2021 CMOM Package 1 Solicitation Number: CO-00658 Job No.: 22-4512

ADDENDUM 4 November 9, 2023

2021 CMOM PACKAGE 1 OLMOS BASIN PLAN & PROFILE - OPEN CUT BUDGET PROJ. APPROVED MAP NO. 162602 SHEET SECT. NO. 10 OF 47 DR. SN CK. SO JOB NO. 22-4512

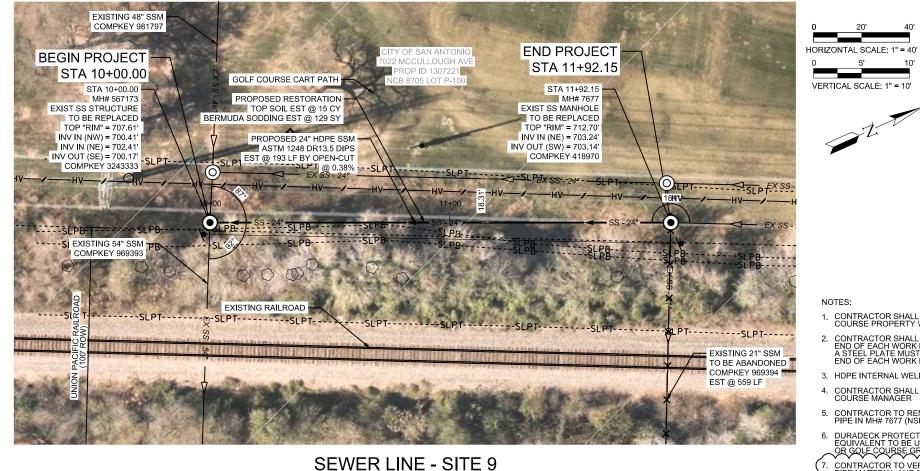
- 1. **Remove** sheet 10 in its entirety and **replace** it with the attached version. Bidders shall use the revised sheet 10 attached to this addendum. The following items were updated:
 - a. Sanitary Sewer Structure 01 sizing was revised to become an 8' manhole.
 - b. Note 7 added.
 - c. Callout added referencing Note 7.
